**ADDENDUM NO. 1
FEBRUARY 26TH, 2026**

PROJECT: ANSON ISD
ELEMENTARY & HIGH SCHOOL CLASSROOM ADDITION

BID DATE: MARCH 5TH, 2026

FRAMING DETAILS

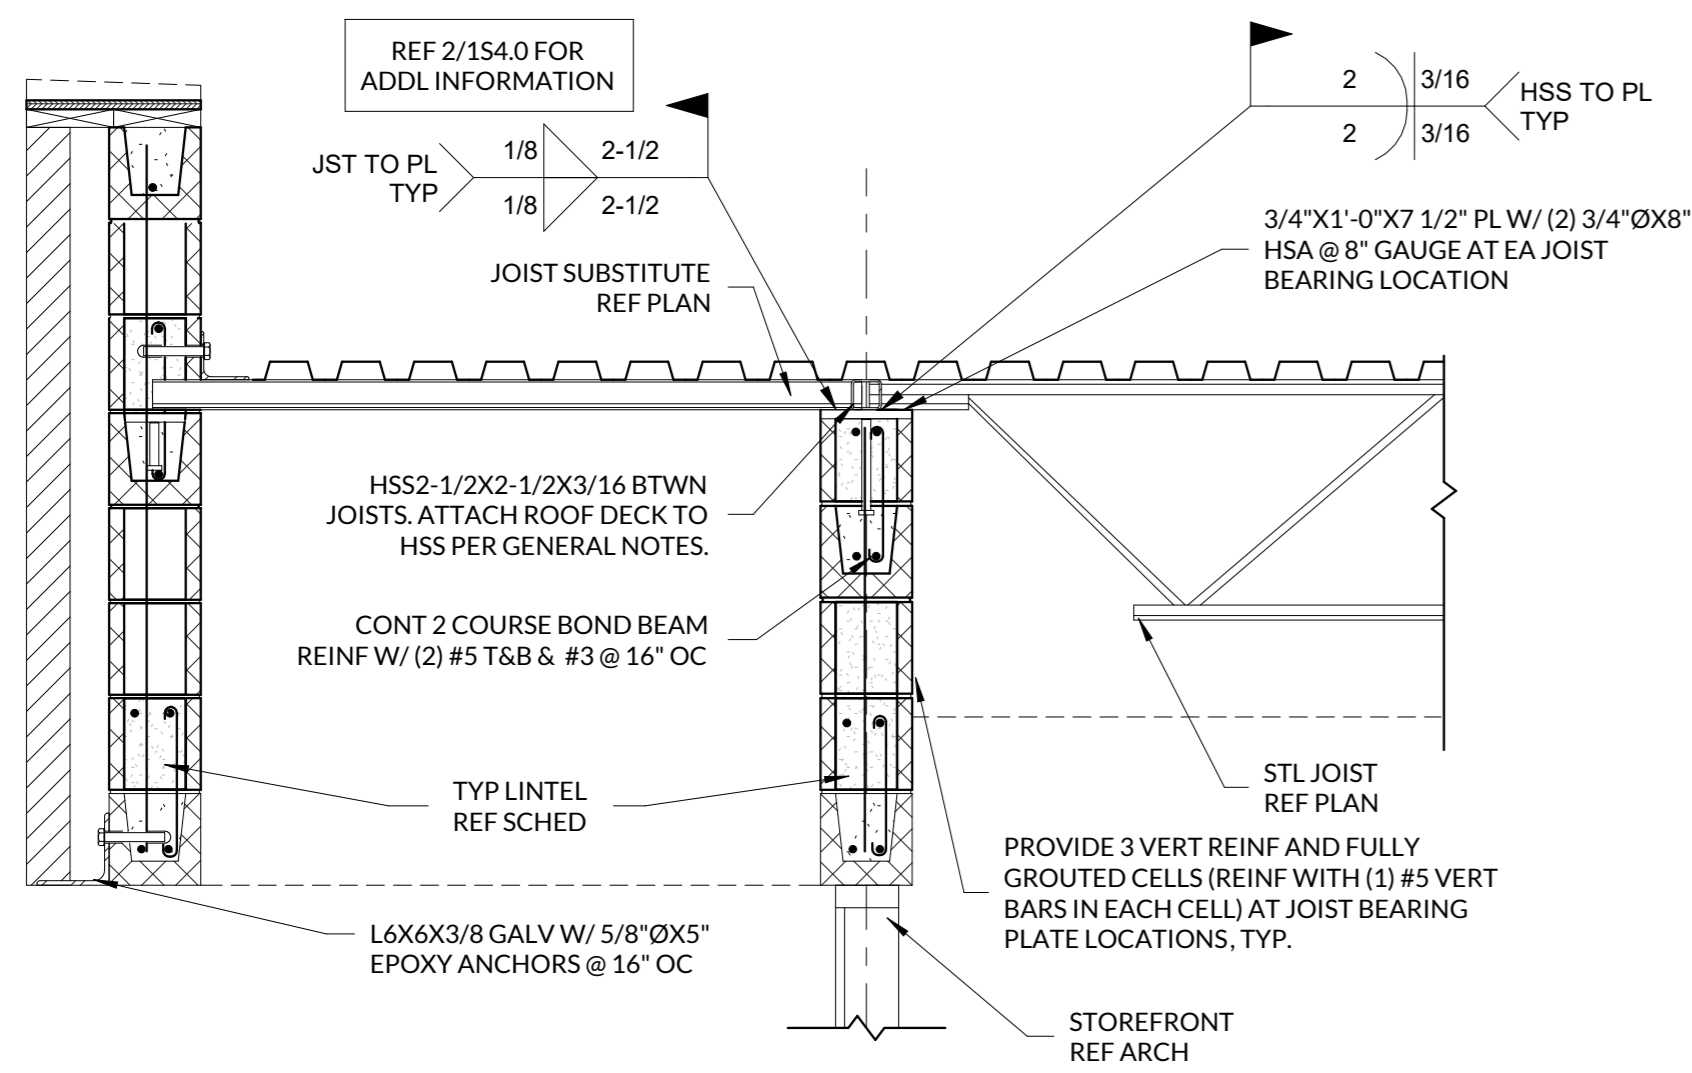
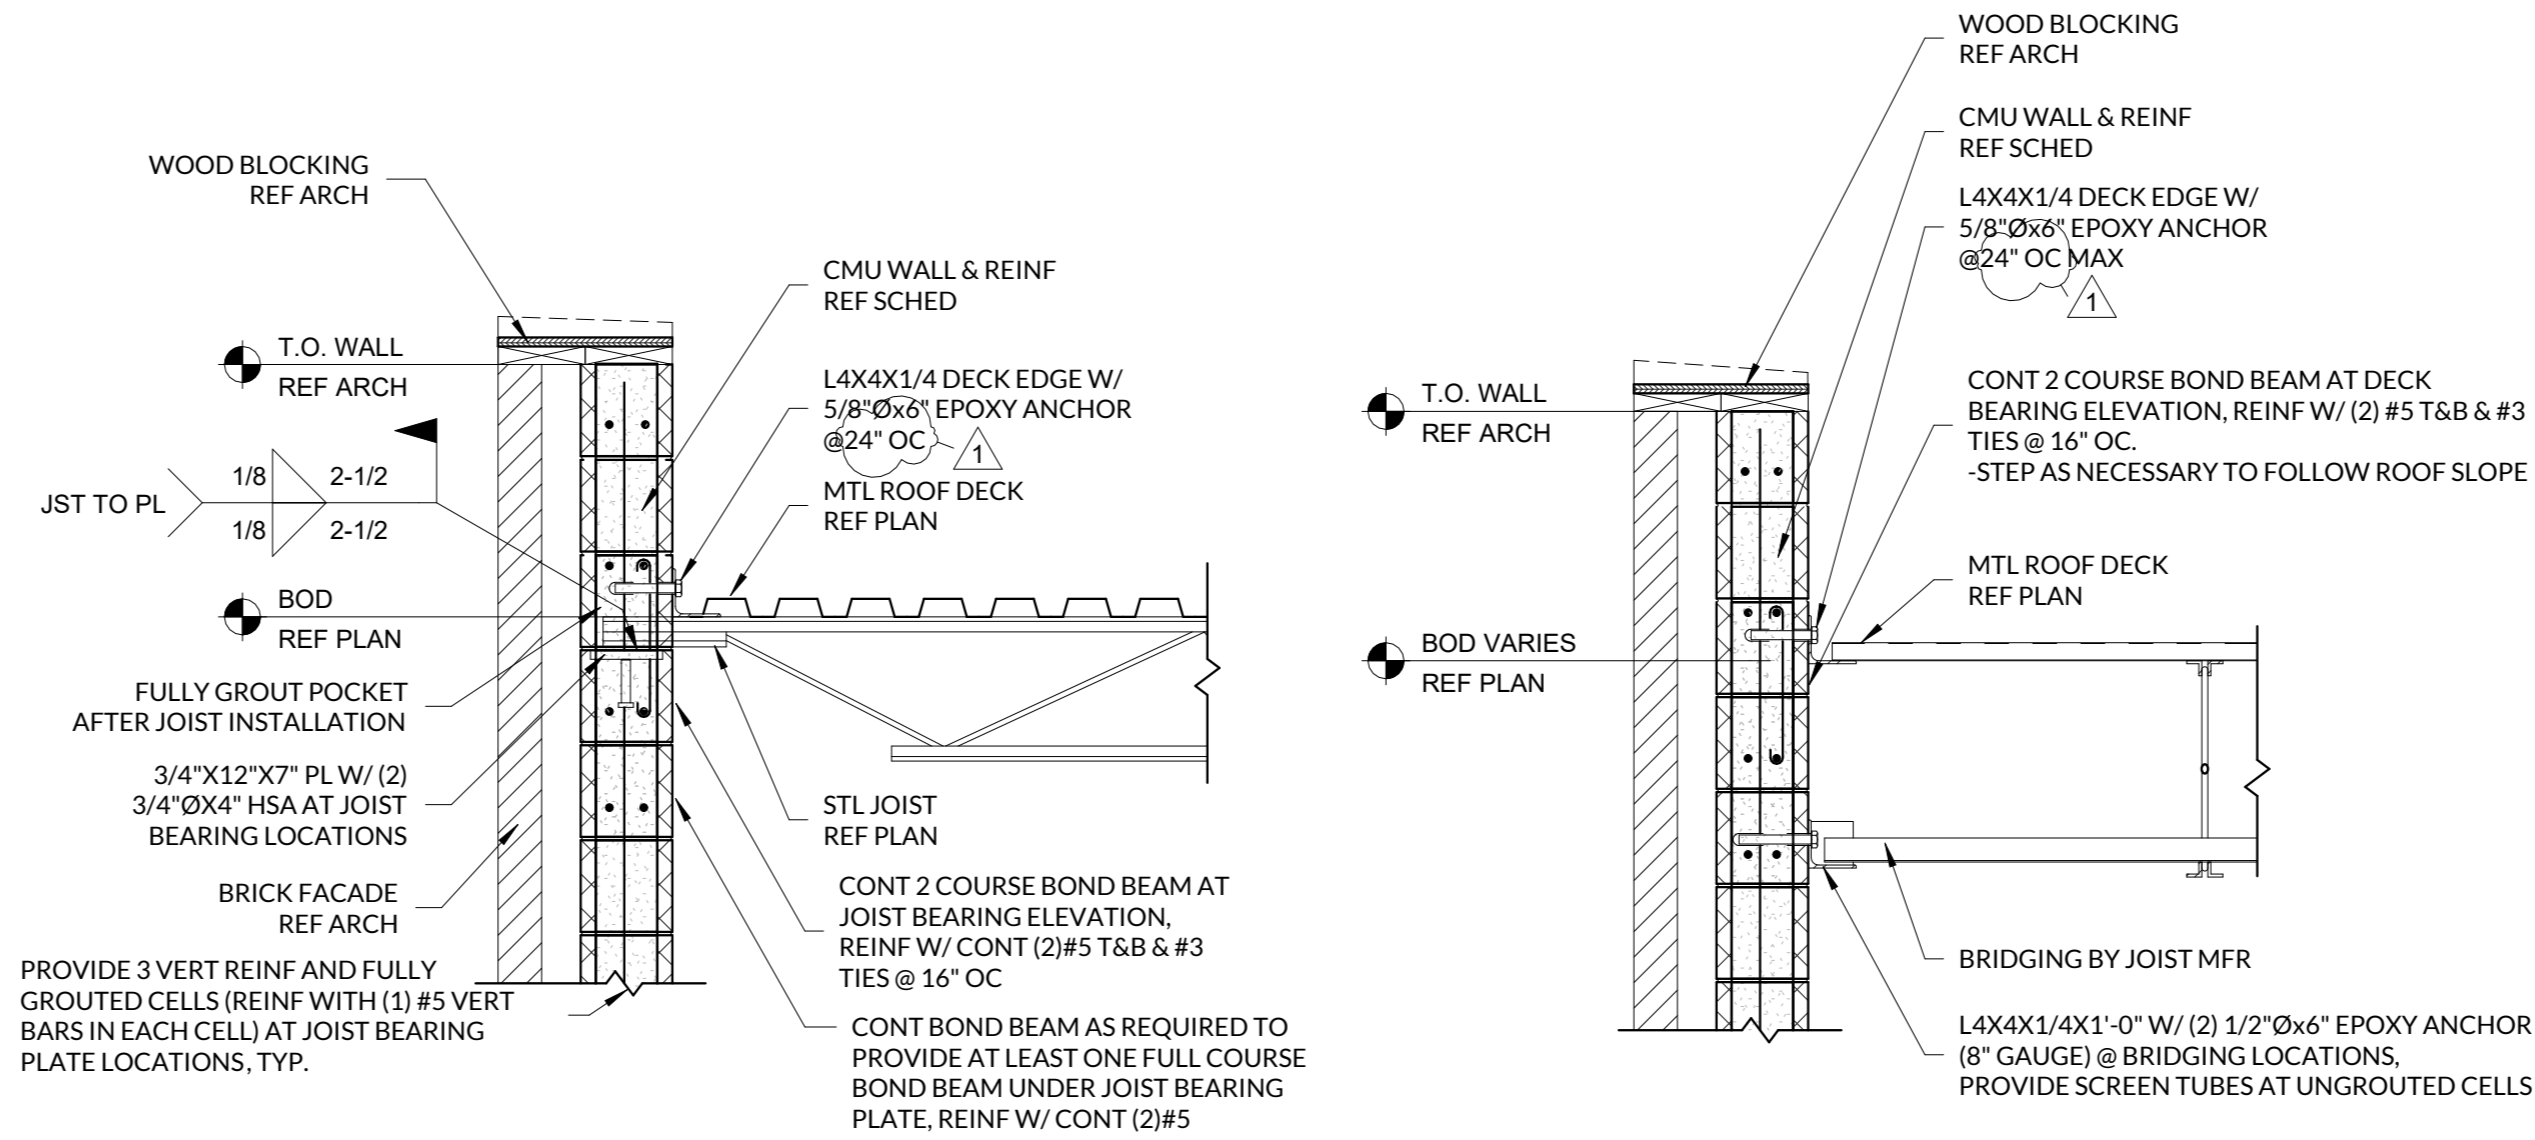
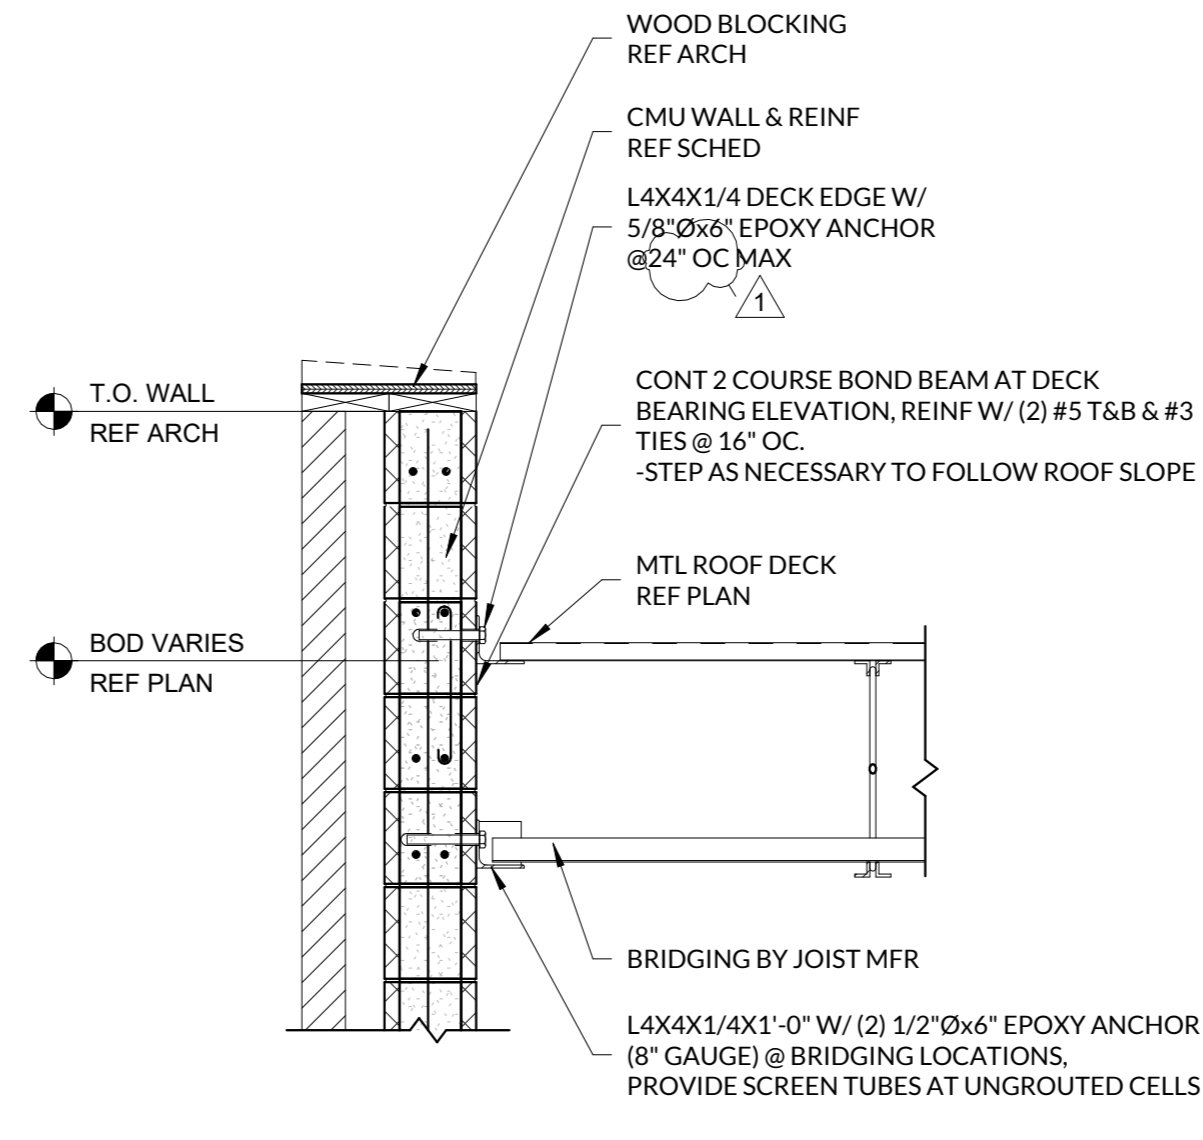
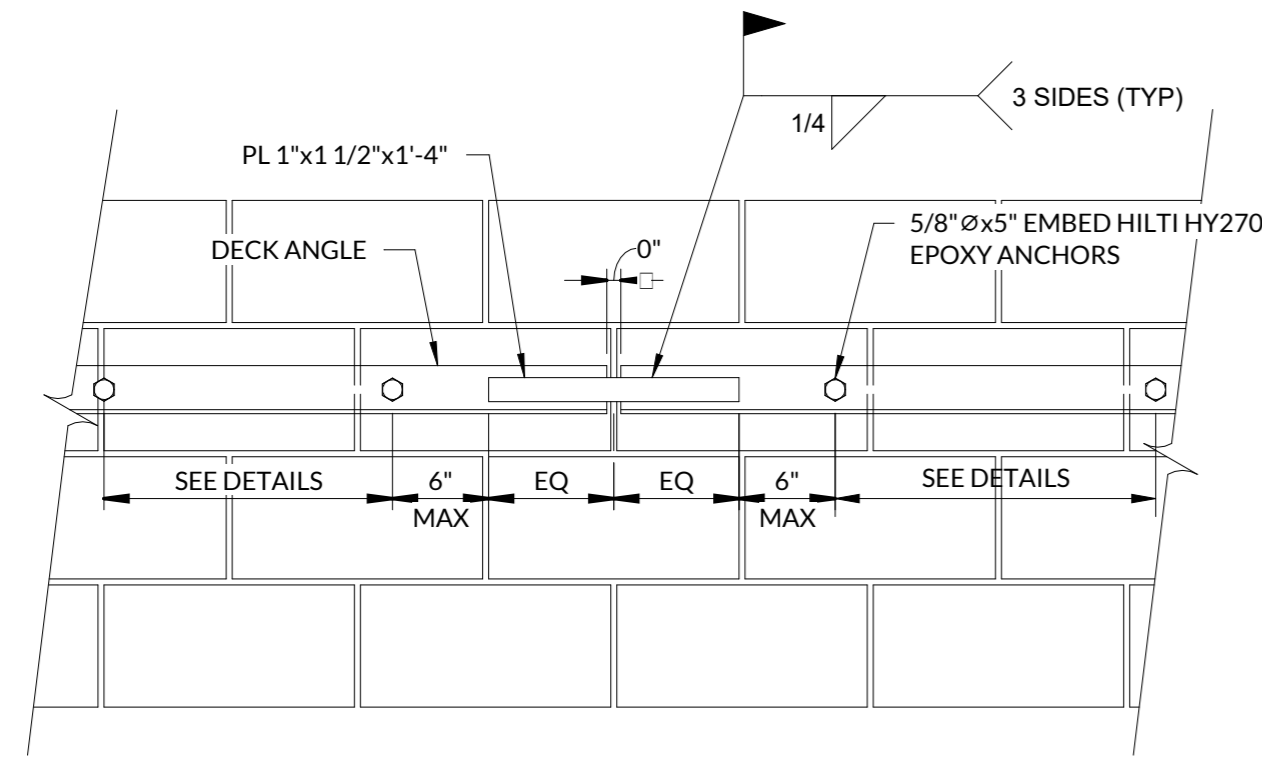
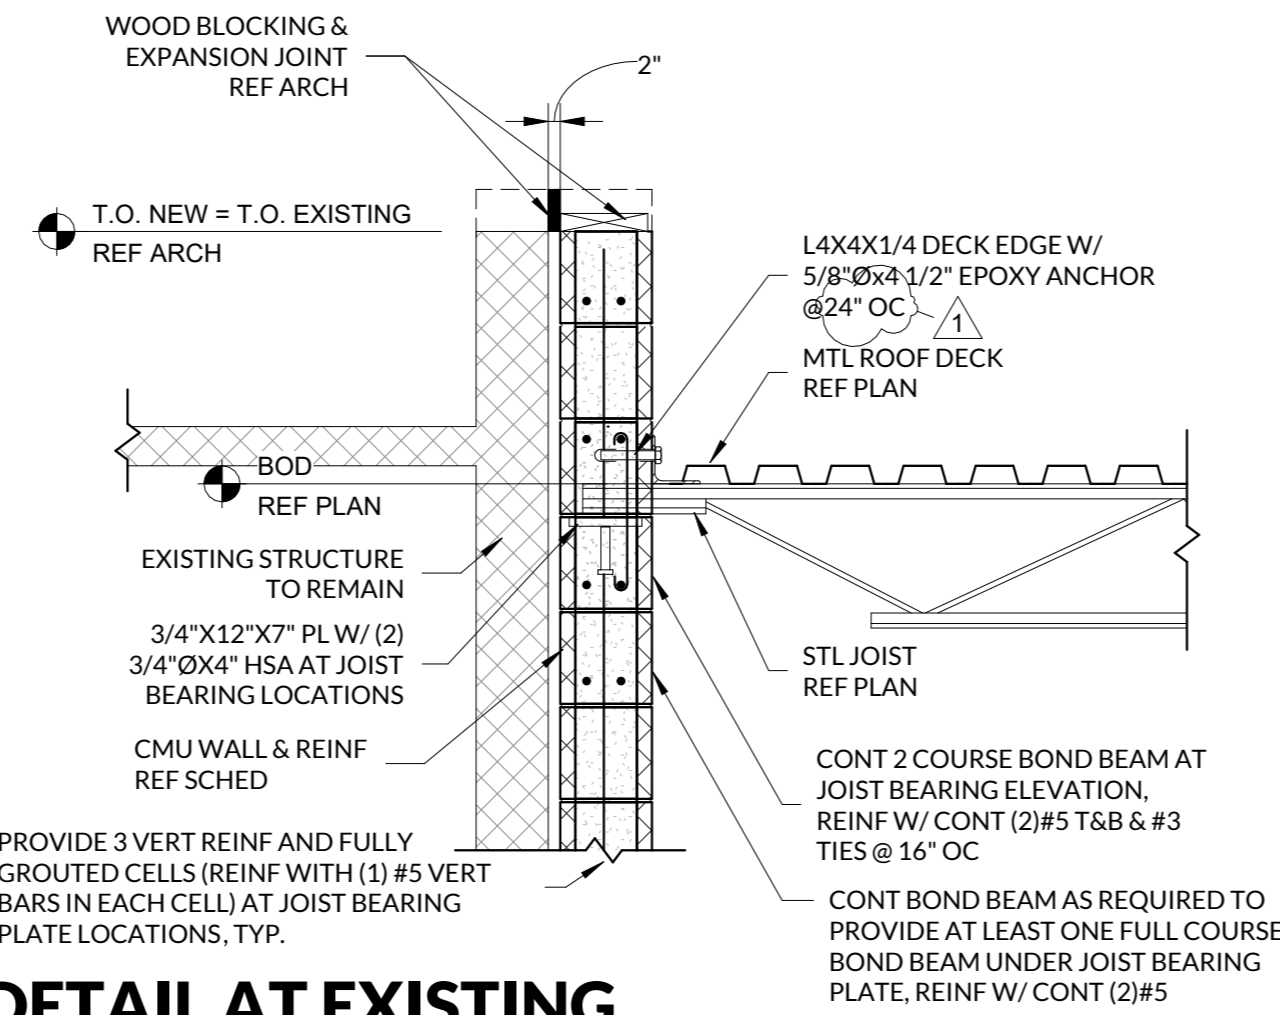
- Item #D5** **Sheet 1S2.0** – REPLACE sheet with attached sheet 1S2.0 dated 02-26-2026. REVISED bottom of deck elevations.
- Item #D6** **Sheet 1S4.0** – REPLACE sheet with attached sheet 1S4.0 dated 02-26-2026. REVISED framing details.
